**RE: RECONDITIONING FACILITY (K20-D47). GRADING AND DRAINAGE PLAN
SUBMITTAL FOR BUILDING PERMIT APPROVAL. ENGINEER'S STAMP
DATED SEPTEMBER 25, 1997.**

**RE: RECONDITIONING CENTER WYOMING BLVD. DEALERSHIP (K20-D47).
GRADING AND DRAINAGE PLAN SUBMITTAL FOR BUILDING PERMIT
APPROVAL. ENGINEER'S STAMP DATED 3-11-97.**

RE: REVISED DRAINAGE PLAN FOR THE WYOMING BLVD. DEALERSHIP
(K20-D47) REVISION DATED 6/3/97

GRADING AND DRAINAGE PLAN

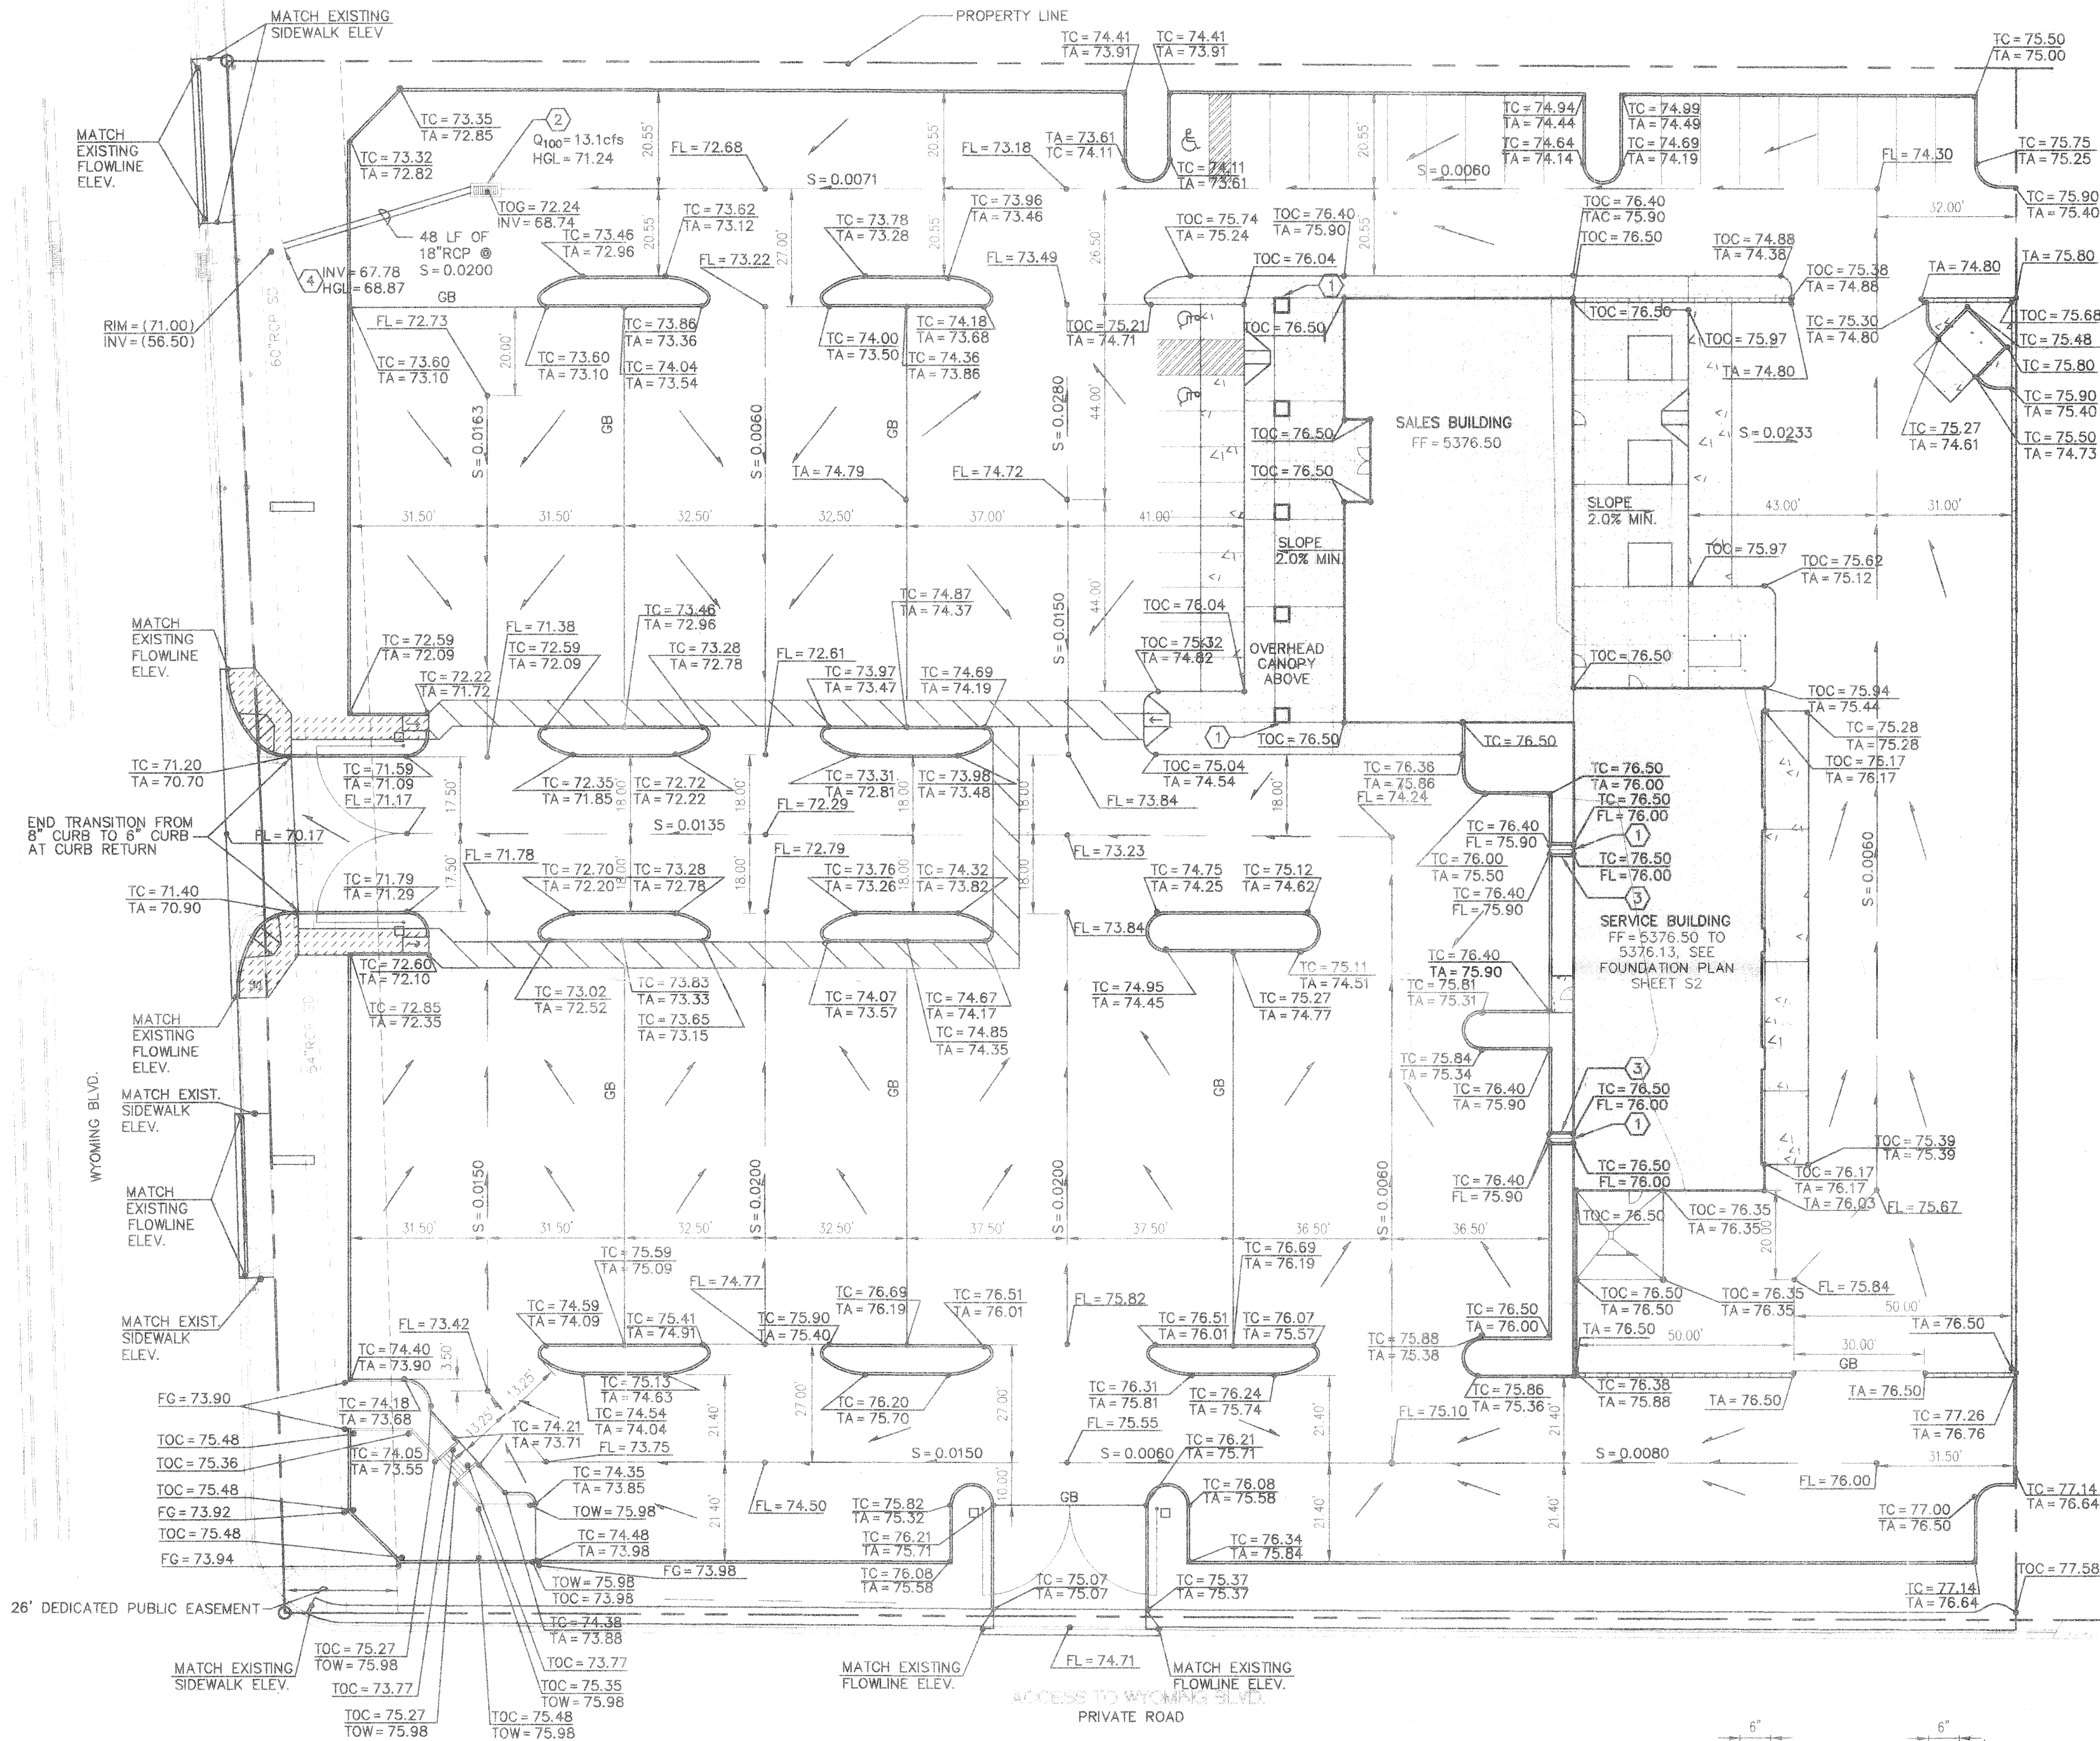
1. It appears that this project is an integral part of the dealership building to the west. Both projects should have been submitted together.
2. My letter dated March 4, 1997 had several comments on the dealership building to the west of this project. Until those issues are resolved, this project cannot be approved.
3. It has come to my attention that item number 1, on my March 4, 1997 letter, may not be required. You may install curb and parking in the City right-of-way.

Based on the information provided on your on your June 5, 1997 resubmittal, the above referenced site is approved for Building Permit.
